4880 MANOR LANE
 TAX MAP 29, PARCEL 121, 1.0 ACRES
 HOWARD COUNTY, MARYLAND
PERCOLATION CERT. PLAN

From: Oswald Jr, Woodin
Sent: Monday, June 10, 2024 10:27 AM
To: 'jim@jnmengineeringllc.com'
Cc: 'Winston Bower'
Subject: Perc Cert Plan Review Comments_4880 Manor Lane

Good morning. The perc cert plan for 4880 Manor Lane has been reviewed with the following comments:

4880 MANOR LANE
 ELLICOTT CITY, MD 21042
 DEED 21936/342, PARCEL 121,
 MAP 29, GRID 11
 1.0 ACRES, ACCT#03-297497
PERCOLATION CERTIFICATION PLAN

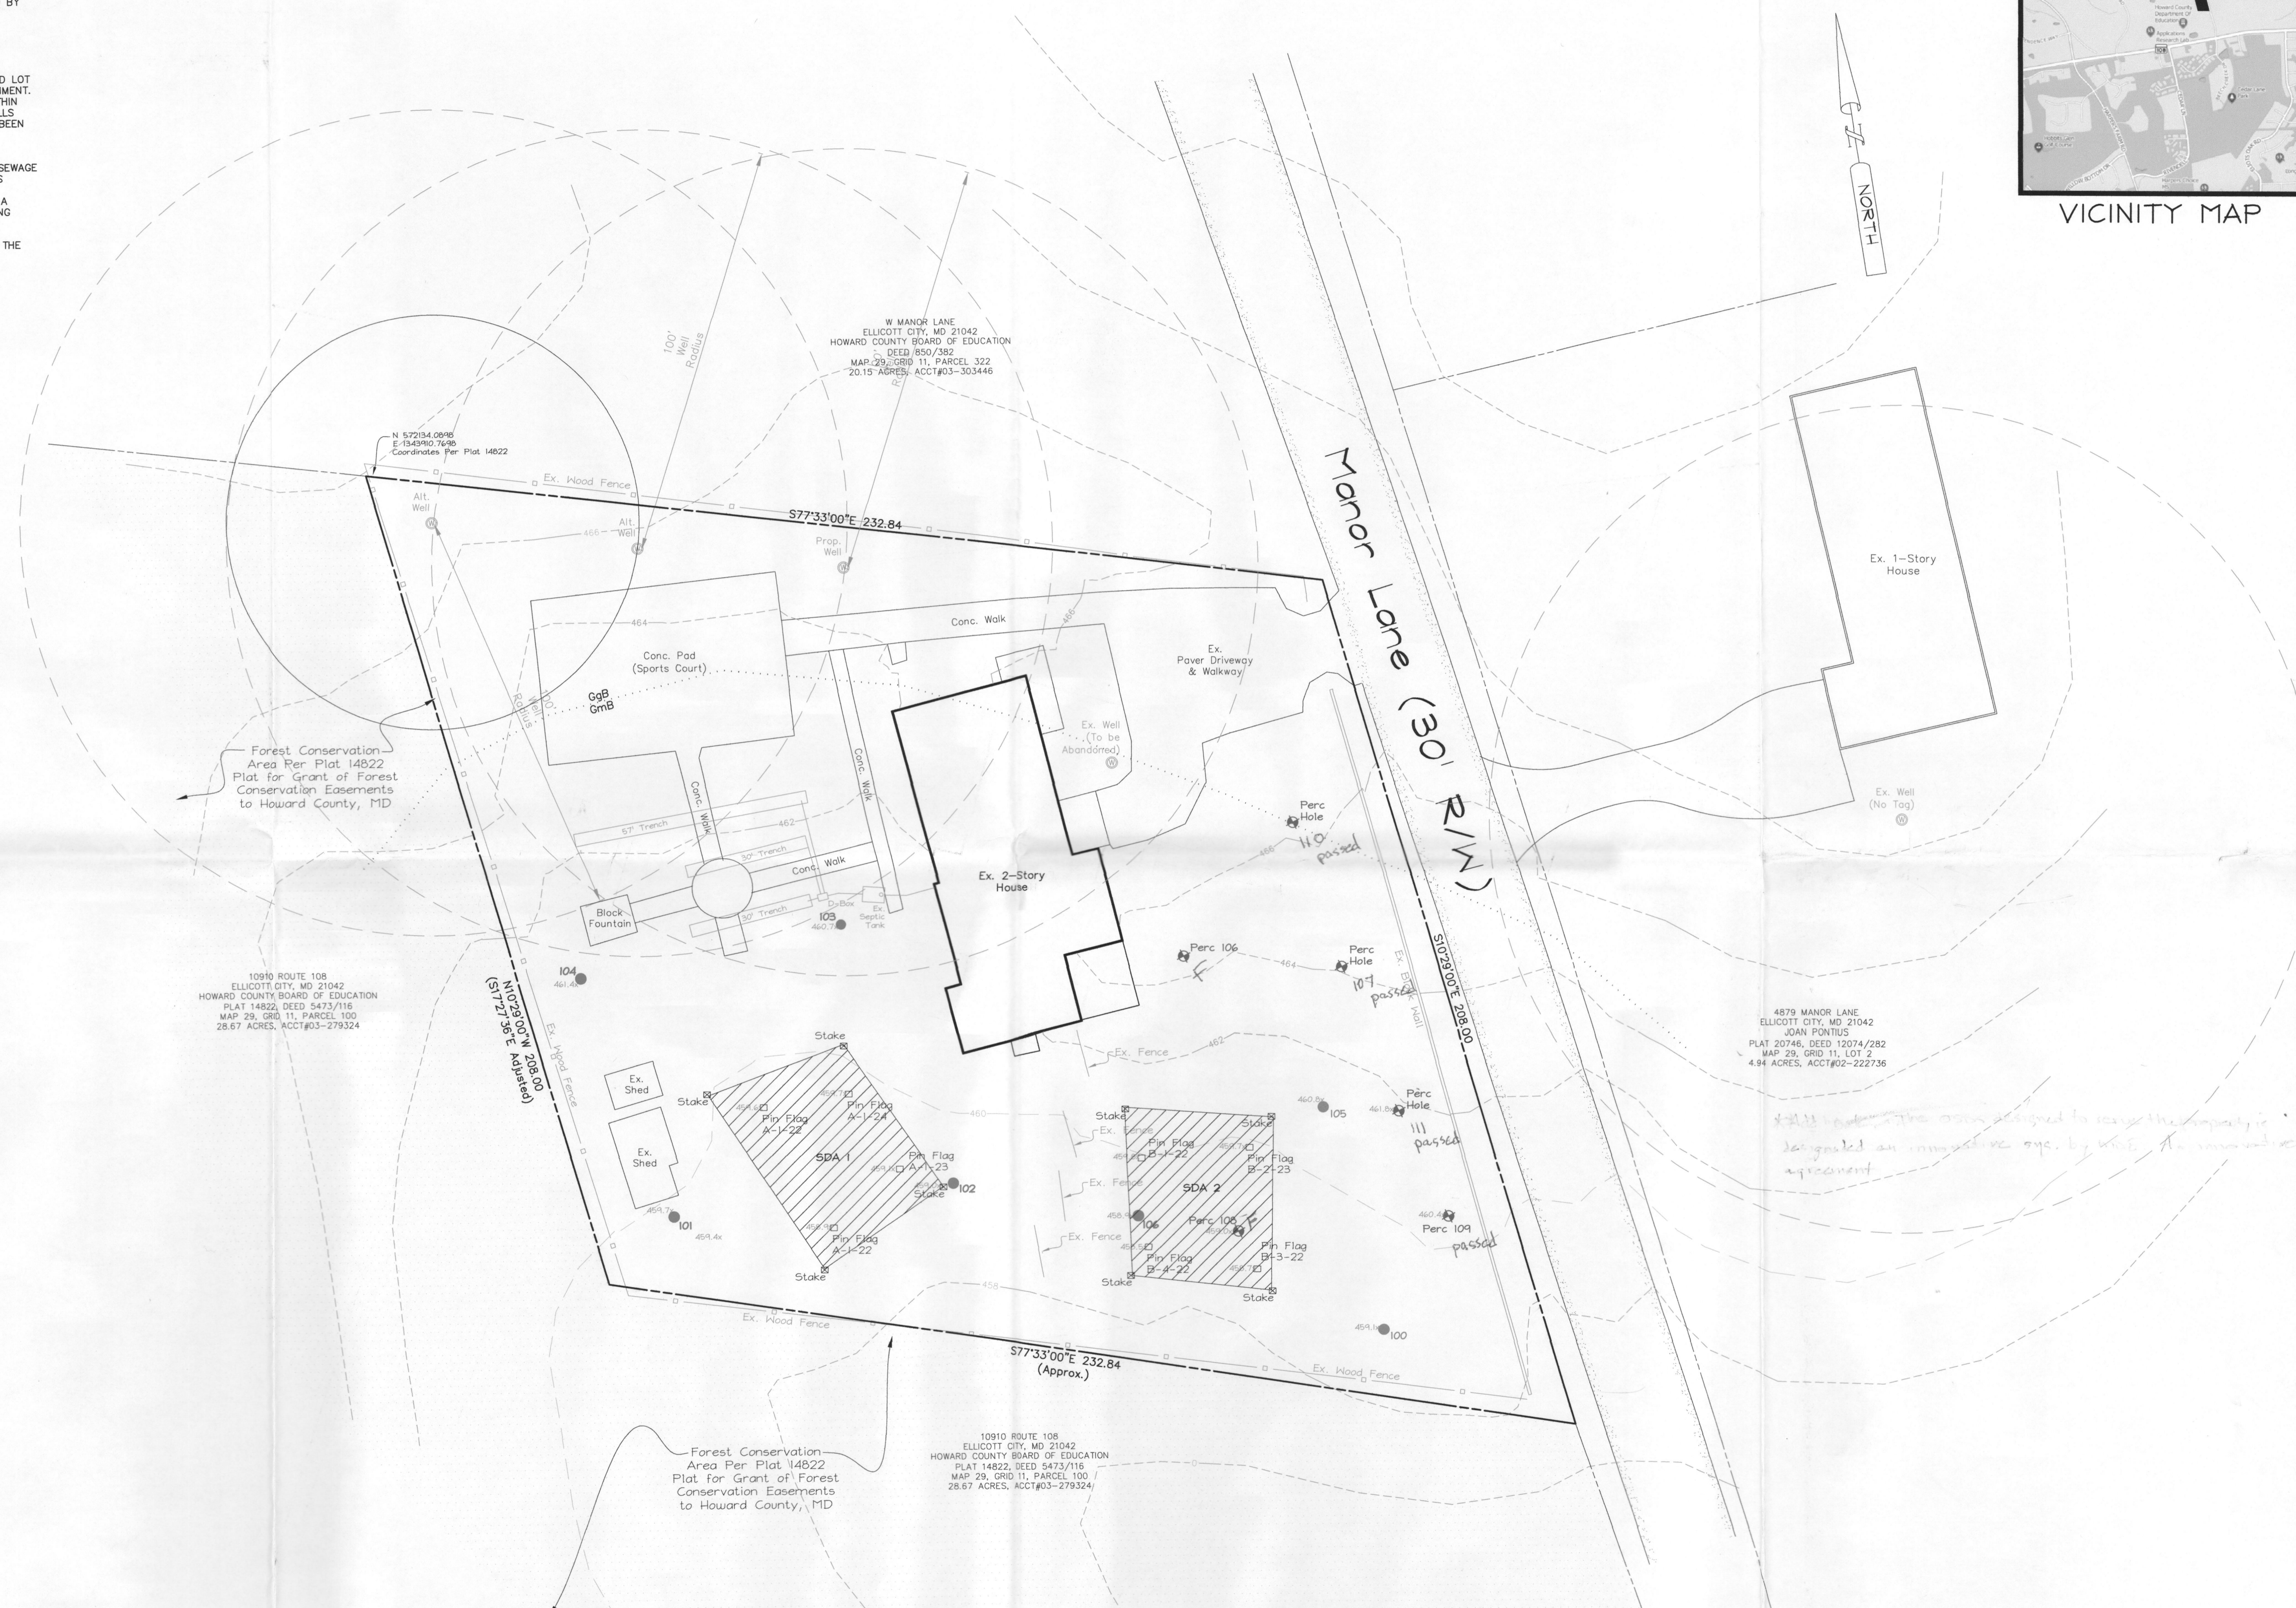
1. Change note #12 to read; The next OSDS designed to serve this property has been designated an innovative system by MDE. An advanced treatment unit will be required. The future septic systems were designed by Tom W. Ashton REHS. An innovative agreement signed by the owner, the Health Department and MDE must be recorded in Land Records for the property prior to the release of a septic permit.

2. Add note; The septic system is designed for 4 bedrooms. There is no availability to increase the number of bedrooms without prior permission from MDE.

3. Change note #13 to read; The existing well must be abandoned, a new well must be drilled and completion report received prior to Health Dept approval of a building permit.

4. Add note; Locate, fence or rope-off the initial and sewage disposal areas prior to building permit approval. Vehicular traffic over the disposal areas is prohibited to avoid soil compaction and could render the lot non-buildable if ignored. There should be no disturbance of the protested area at all.

5. Add note; Existing septic system to be abandoned at time of new septic install.
6. If no tag on existing well, then add "no tag" next to existing well on plan.

7. A design plan for the innovative system must be approved by MDE and HCHD and the system must be installed under a permit from HCHD to the specifications outlined in the approved design plan. The septic permit must be issued prior to building permit approval.

8. Separate out purpose statement from general notes and place above address.
9. Delete legend symbol for existing sewage disposal area (SDA). It's not shown on the plan and correct proposed SDA legend key. Currently, it does not match plot plan.

10. Add square footage for proposed SDA locations. Label proposed.
11. Delete legend symbol for old perc test data.
12. Delete the letter "D" from the word run in note #4

13. Add appropriate #'s to the test holes sites in front of property near wall.
14. Test holes 107, 109, 110, and 111 passed. Change symbol on plan to match legend.

15. Test holes 106 and 108 failed. Change symbol on plan to match legend.
16. Add well radius around existing well.
17. Ensure the 100 ft. well radius is centered on the symbol used on the plan.

18. Add required BAT notes.

I've reviewed the perc cert plan. Comment #7 was a note that was supposed to be added to the plan. Also, the SDA's weren't labeled "Proposed". The 2nd sentence in note #17 isn't necessary. I could redline the plan with the note, label the SDAs and cross out the sentence in note#17. Or if you would like, you may resubmit. Please let me know.
